APPENDIX C

COMMENTS AND RESPONSES

APPENDIX C-1
COMMENTS AND RESPONSES

**City of Bloomington Office of the Common Council (BCC)01
Letter from BCC to Robert F. Tally (FHWA-IN) – 08/22/2011**

IKC01-07

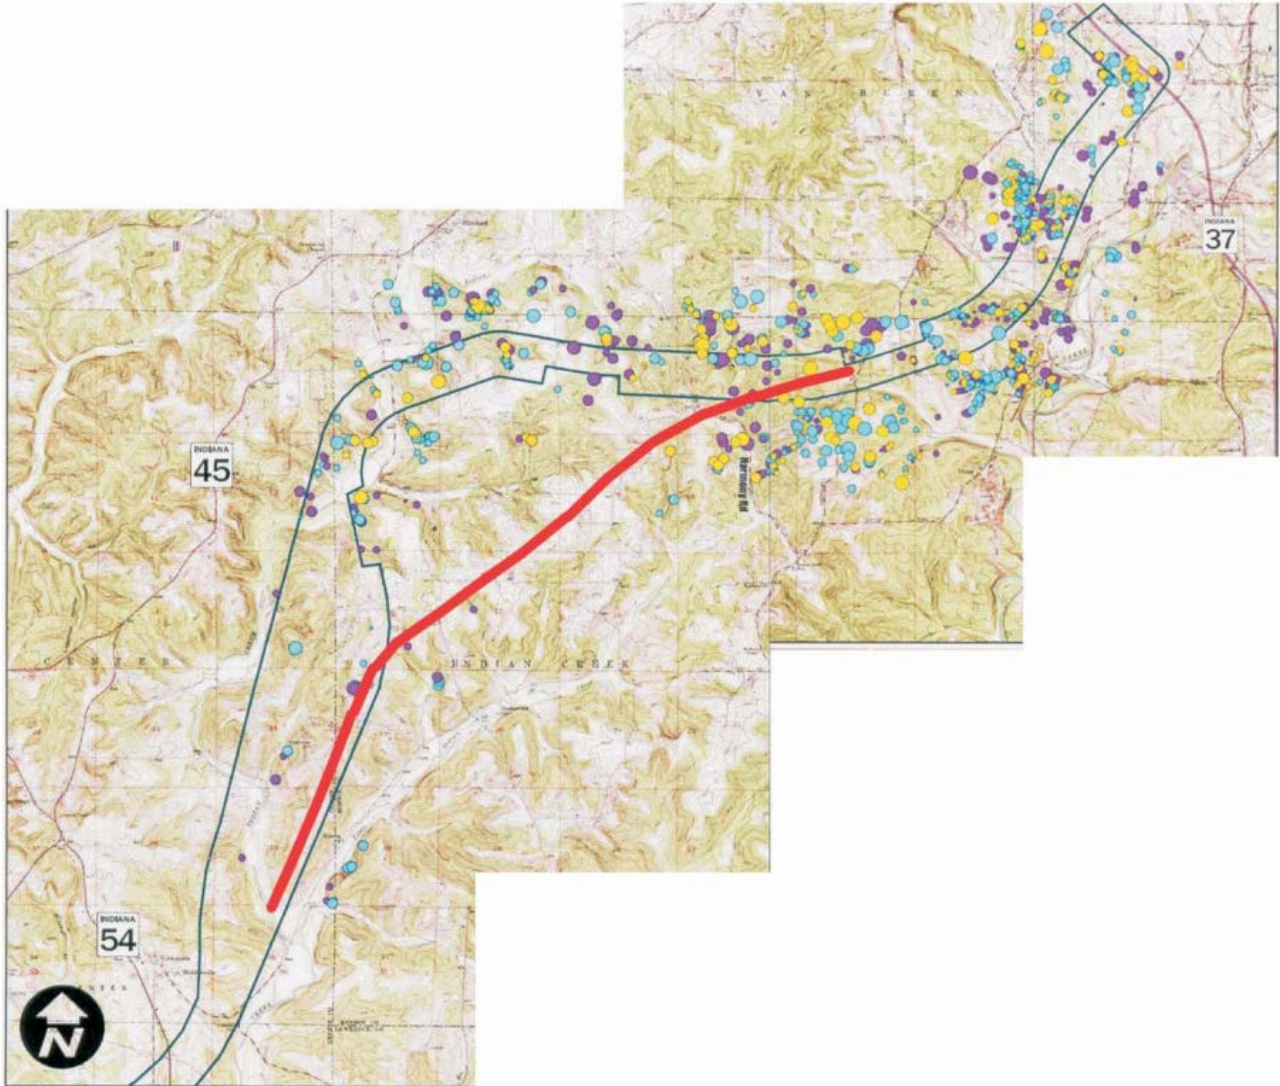
Please see the IKC's DEIS for more specifics of the merits of its proposed alignment.

Response: See Responses to Comments IKC 01-02 through 01-05.
